ROADWAY PLANS

JUDGE ORR ROAD RV PARK AND STORAGE

EL PASO COUNTY, COLORADO

Markup Summary

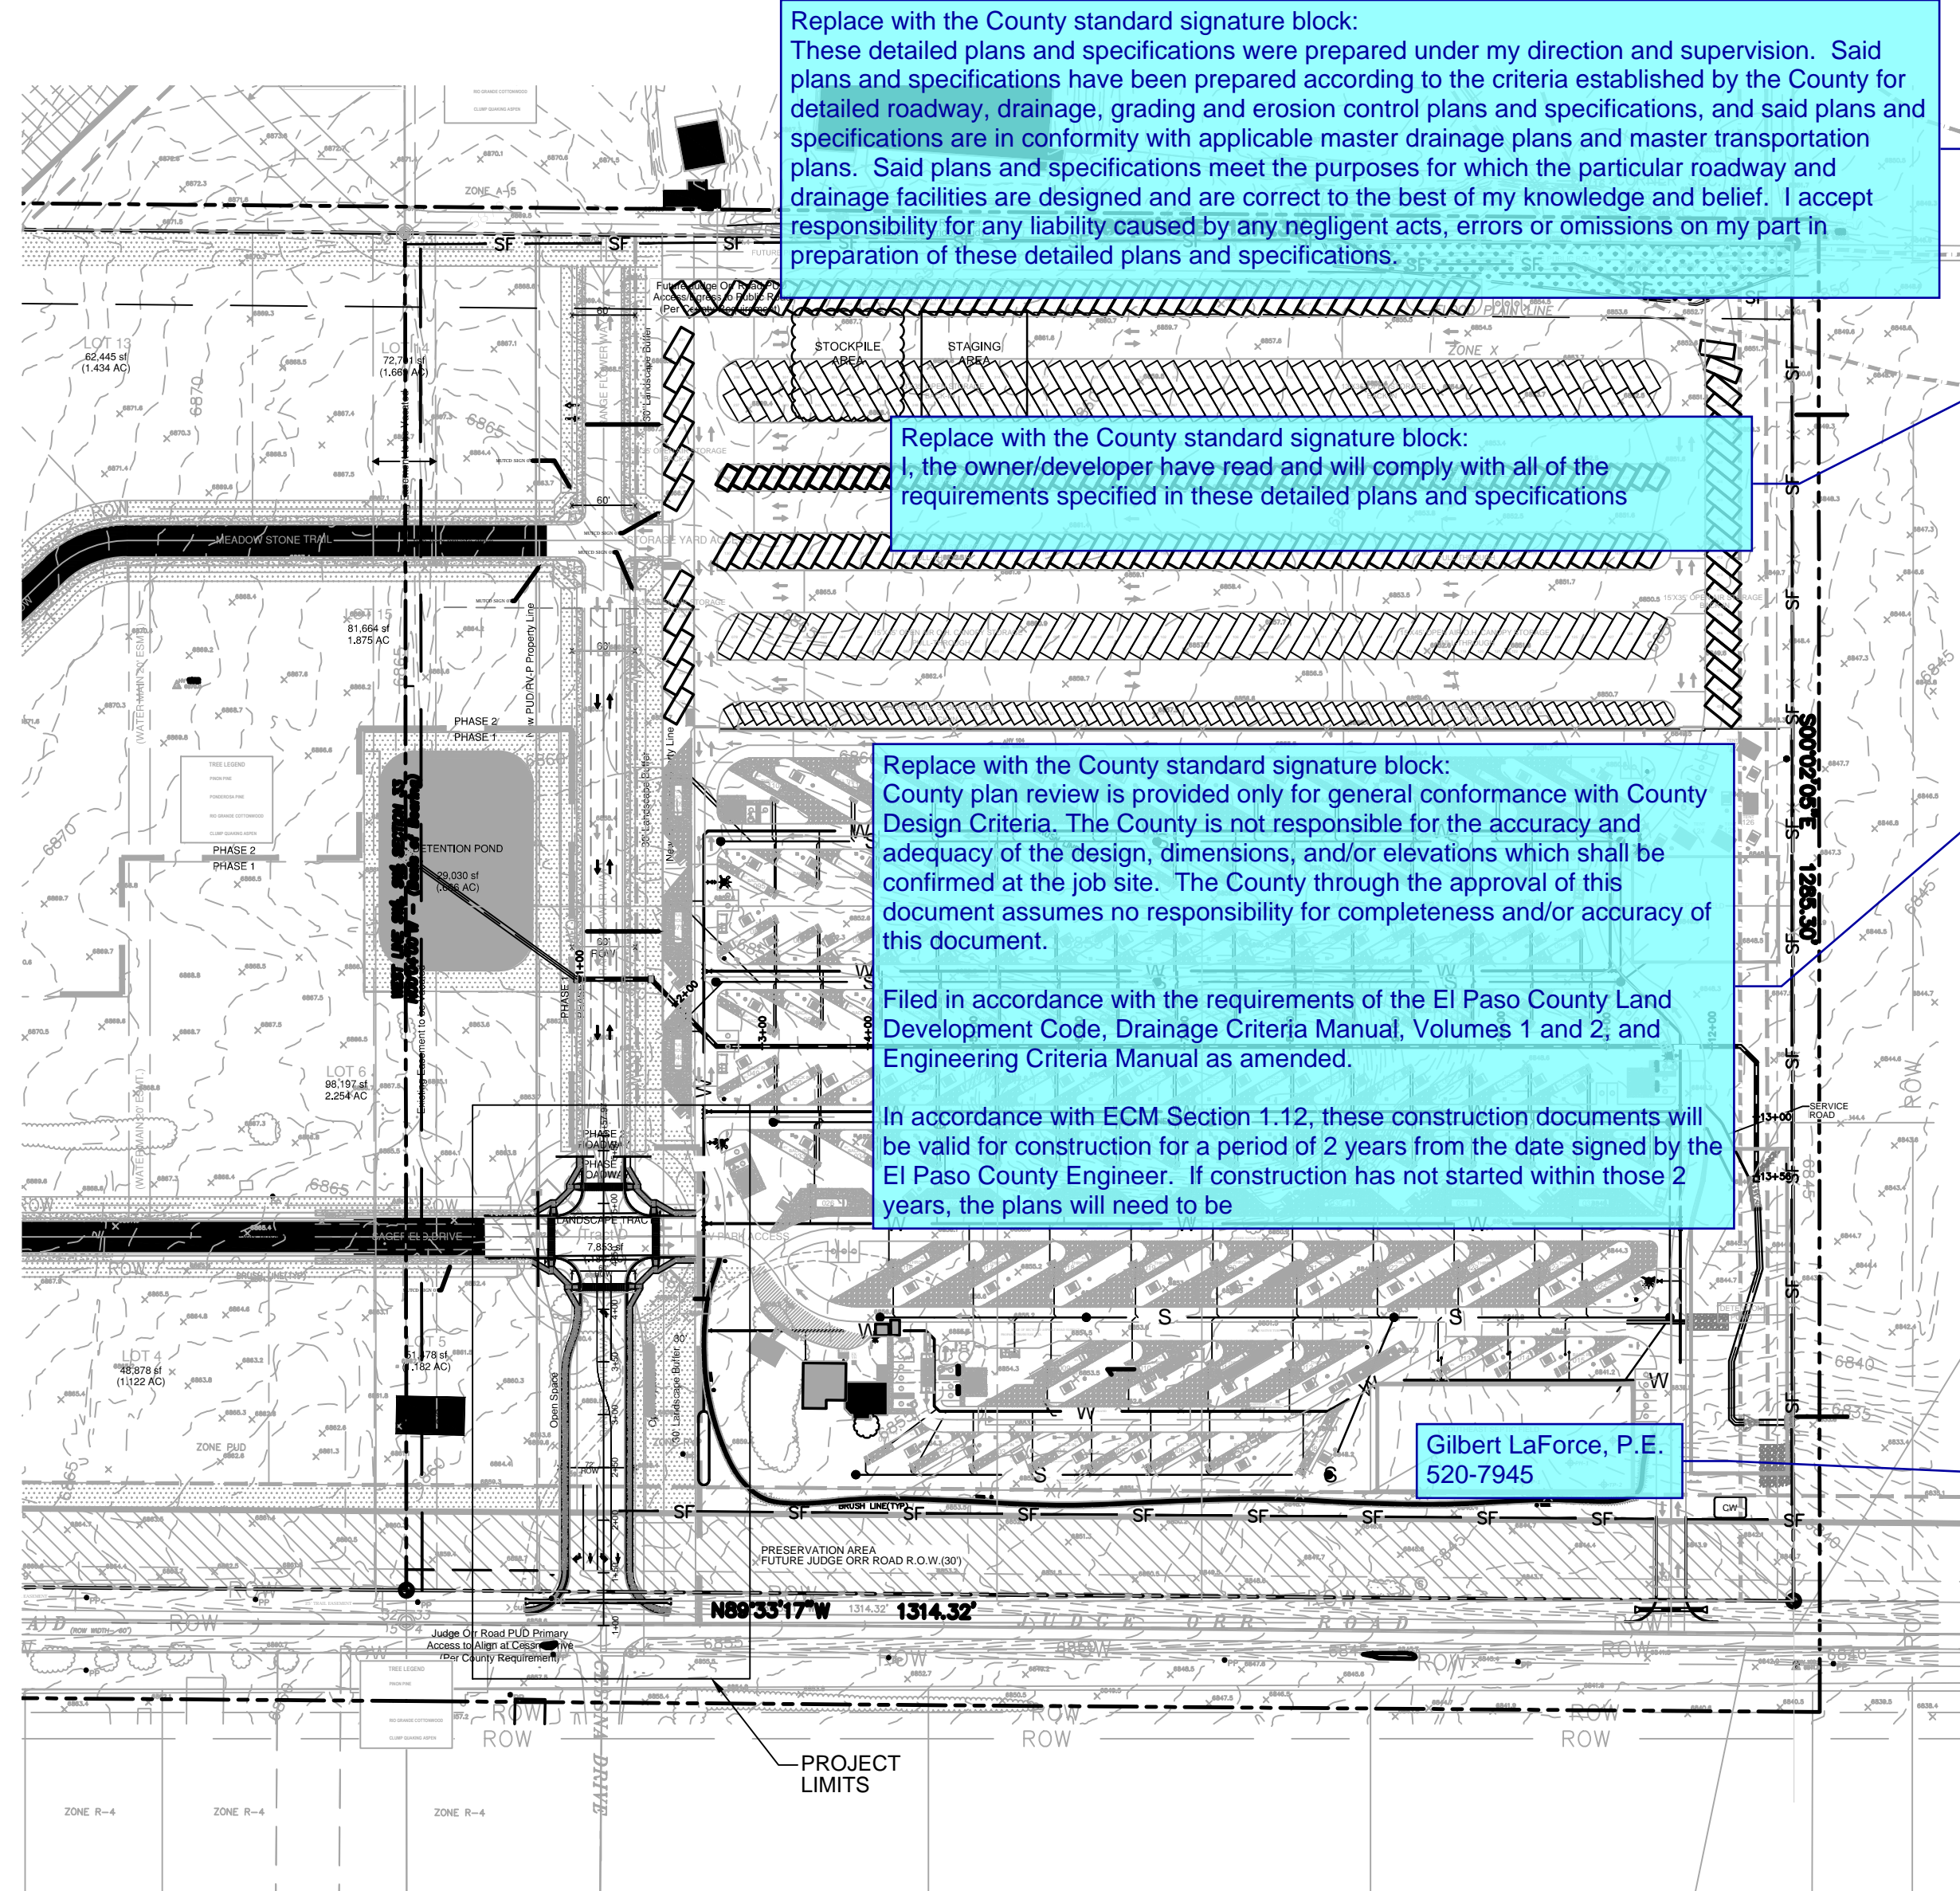
Provide benchmark and basis of bearing

Replace with the County standard signature block: These detailed plans and specifications were prepared under my direction and supervision. Said plans and specifications have been prepared according to the criteria established by the County for detailed roadway, drainage, grading and erosion control plans and specifications, and said plans and specifications are in conformity with applicable master drainage plans and master transportation plans. Said plans and specifications meet the purposes for which the particular roadway and drainage facilities are designed and are correct to the best of my knowledge and belief. I accept responsibility for any liability caused by any negligent acts, errors or omissions on my part in preparation of these detailed plans and specifications.

Replace with the County standard signature block: I, the owner/developer have read and will comply with all of the requirements specified in these detailed plans and specifications

Replace with the County standard signature block: County plan review is provided only for general conformance with County Design Criteria. The County is not responsible for the accuracy and adequacy of the design, dimensions, and/or elevations which shall be confirmed at the job site.

Identify the roadway classification.
Label as private road.

JUDGE ORR ROAD RV PARK & STORAGE
 COLORADO SPRINGS, COLORADO
 ROADWAY PLAN/PROFILE & STRIPING PLAN

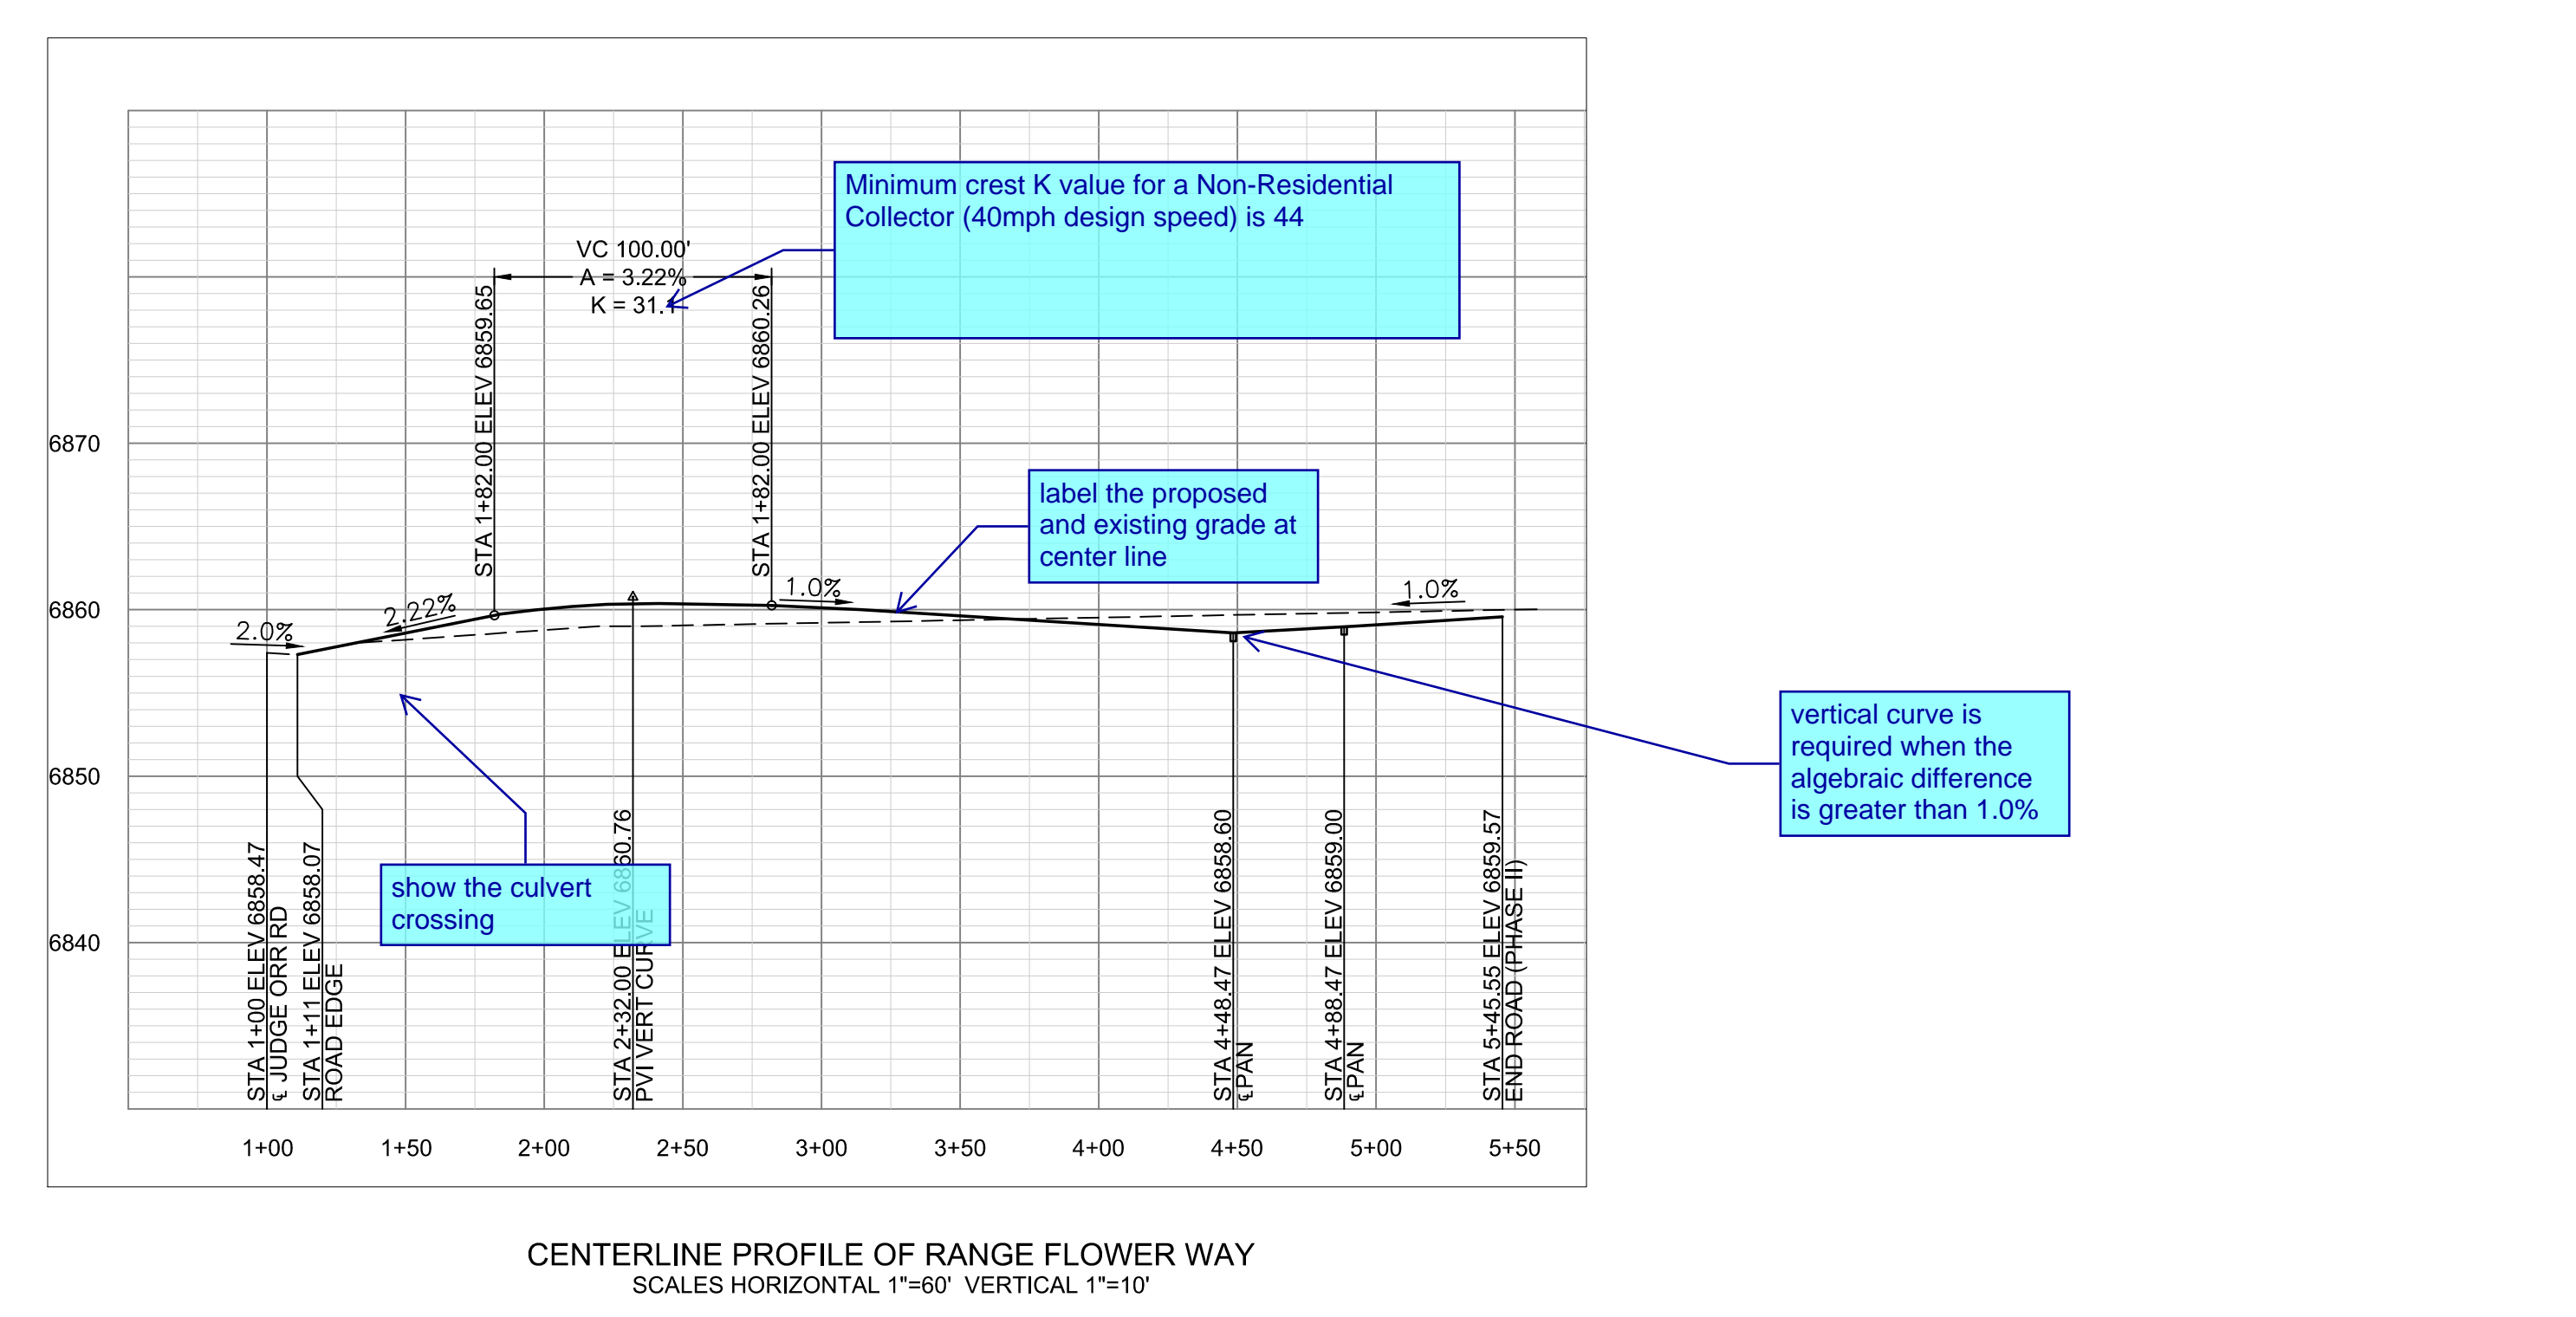
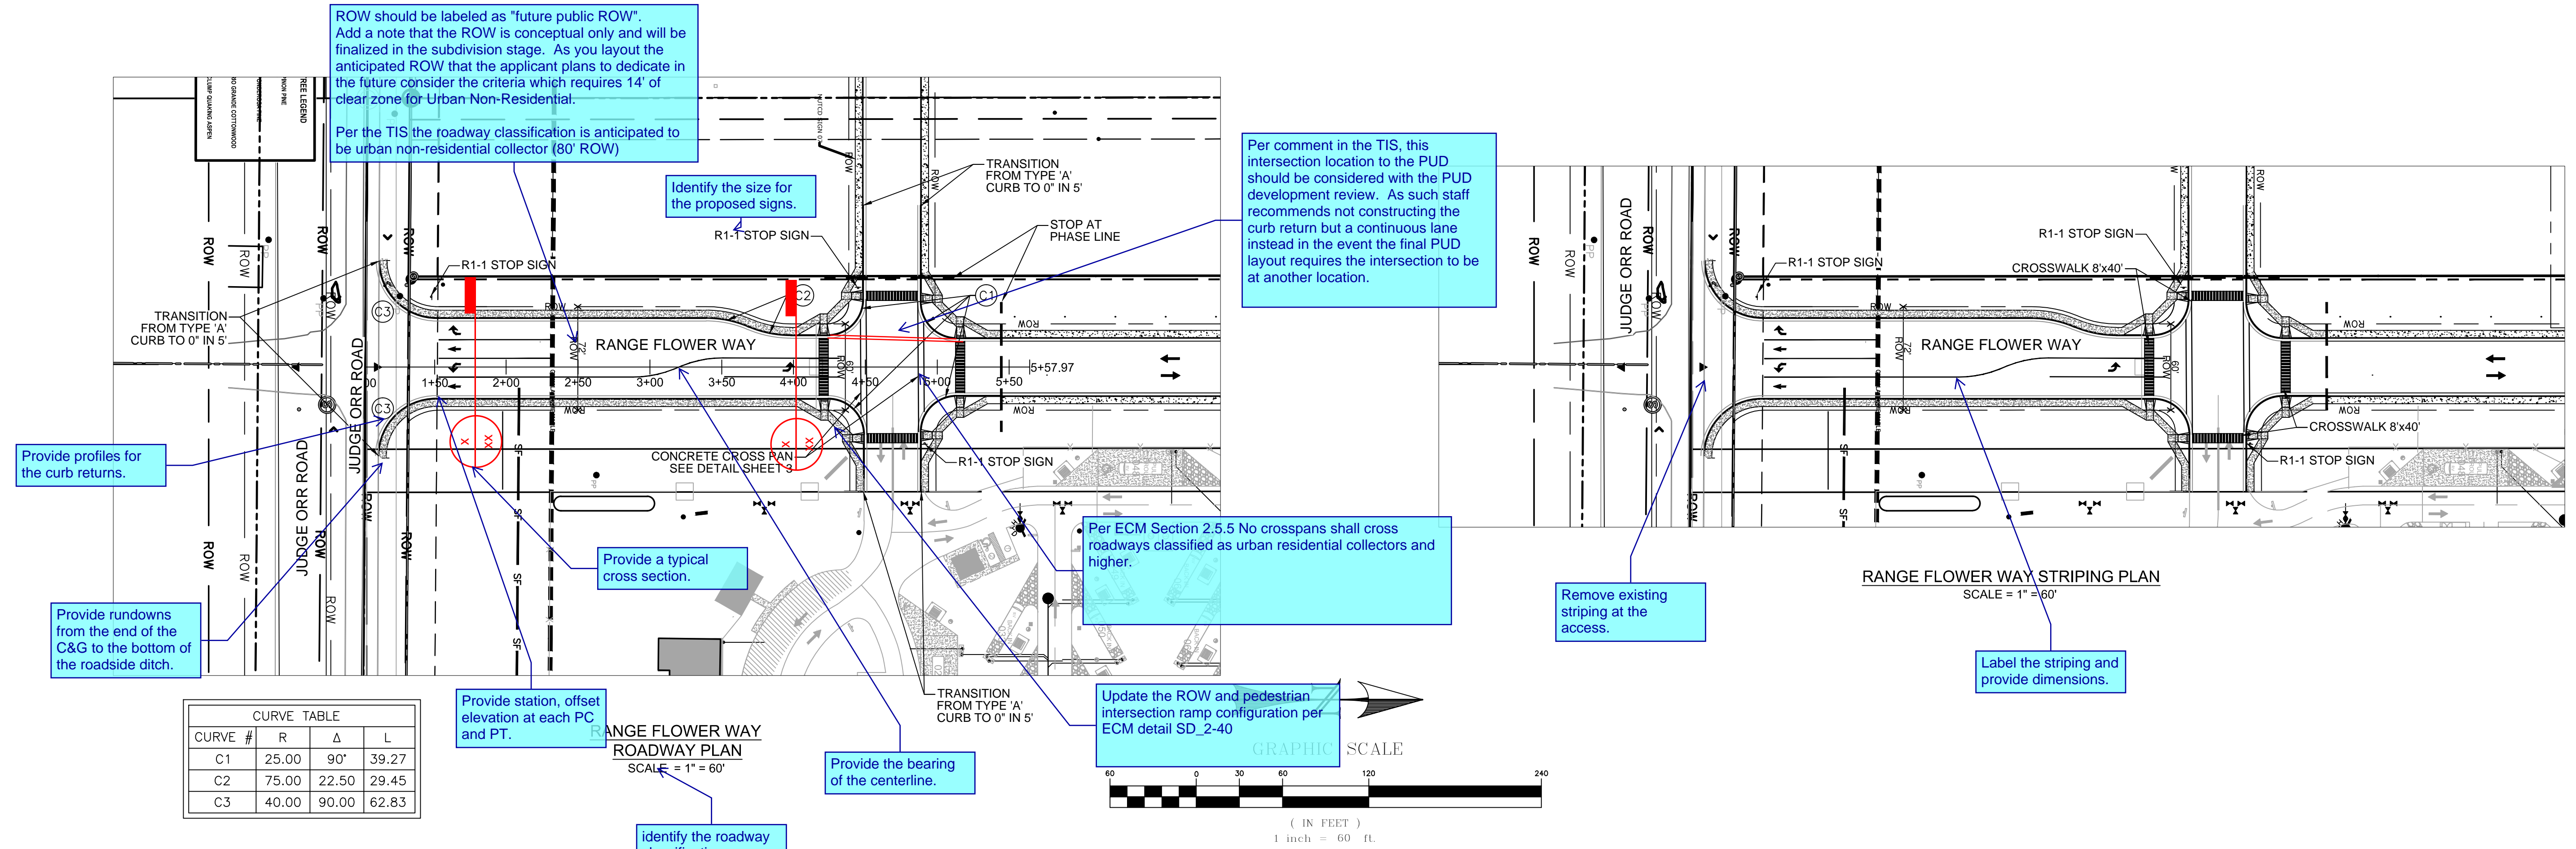
Provide a typical cross section.

ROW should be labeled as "future public ROW". Add a note that the ROW is conceptual only and will be finalized in the subdivision stage. As you layout the anticipated ROW that the applicant plans to dedicate in the future consider the criteria which requires 14' of clear zone for Urban Non-Residential.

Per the TIS the roadway classification is anticipated to be urban non-residential collector (80' ROW)

Per comment in the TIS, this intersection location to the PUD should be considered with the PUD development review. As such staff recommends not constructing the curb return but a continuous lane instead in the event the final PUD layout requires the intersection to be at another location.

Per ECM Section 2.5.5 No crosspans shall cross roadways classified as urban residential collectors and higher.

Provide rundowns from the end of the C&G to the bottom of the roadside ditch.

Provide profiles for the curb returns.

Provide station, offset elevation at each PC and PT.

Provide the bearing of the centerline.

Update the ROW and pedestrian intersection ramp configuration per ECM detail SD_2-40

Identify the size for the proposed signs.

Label the striping and provide dimensions.

Remove existing striping at the access.

show the culvert crossing

label the proposed and existing grade at center line

Minimum crest K value for a Non-Residential Collector (40mph design speed) is 44

vertical curve is required when the algebraic difference is greater than 1.0%

Identify the roadway classification.
Label as private road.
